# Access Compliance Report

## Public Rights-of-Way

### (Curb Ramps)

Intersection ID: 10037289	Main Street: SARDIS_RD_NORTH	Cross Street: N/A	Location: W
ADA ID: 33A460DFF25C	Ramp Type: PerpDiag	Initial Pass/Fail: Fail	Overall Compliance: No
		Severity Score: 12.5

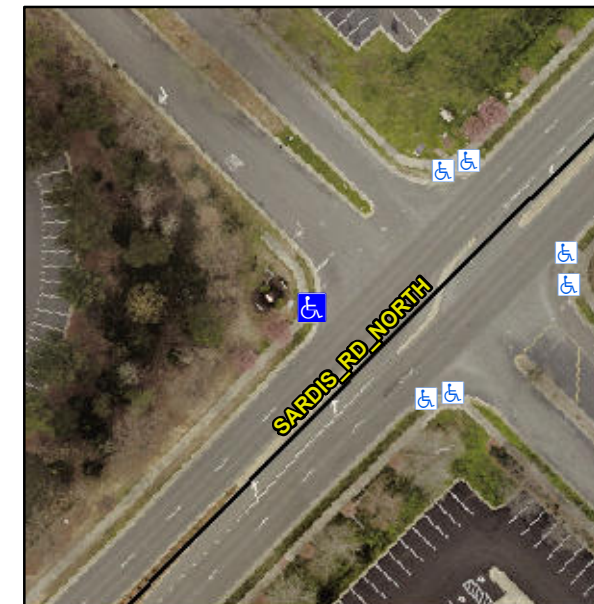
**Not Found, R304.5.3**

Compliance	Description	Data	Compliance	Description	Data
N/A	Ramp Length (in)	96.0	Yes	Ramp Slope (%)	5.8
Yes	Ramp Width (in)	53.0	No	Ramp XSlope (%)	6.2
N/A	Flare Type LT	N/A	N/A	Flare Type RT	N/A
N/A	Flare Slope LT (%)	N/A	N/A	Flare Slope RT (%)	N/A
N/A	Flare Traversable LT?	N/A	N/A	Flare Traversable RT?	N/A
N/A	Landing Length (in)	N/A	N/A	DWS Provided?	N/A
N/A	Landing Width (in)	N/A	N/A	DWS Contrast?	N/A
N/A	Landing Slope (%)	N/A	N/A	DWS Length (in)	N/A
N/A	Landing X Slope (%)	N/A	N/A	DWS Full Width?	N/A
N/A	Landing Curb? (Y/N)	N/A	N/A	DWS Offset (in)	N/A
N/A	Shared Landing?	N/A			
N/A	Gutter Ponding?	N/A	N/A	Gutter Slope (%)	N/A
N/A	Gutter Lip Ht (in)	N/A	N/A	Gutter X Slope (%)	N/A
N/A	Painted X Walk1?	No	N/A	Painted X Walk2?	No
	X Walk 1 Direction	To SE		X Walk 2 Direction	To NE
N/A	X Walk 1 Width (in)	N/A	N/A	X Walk 2 Width (in)	N/A
	X Walk 1 Slope (%)	1.8		X Walk 2 Slope (%)	2.8
	X Walk 1 X Slope (%)	1.5		X Walk 2 X Slope (%)	3.1

**Remove & Replace Curb Ramp With Two New Directional Ramps or Equivalent.**
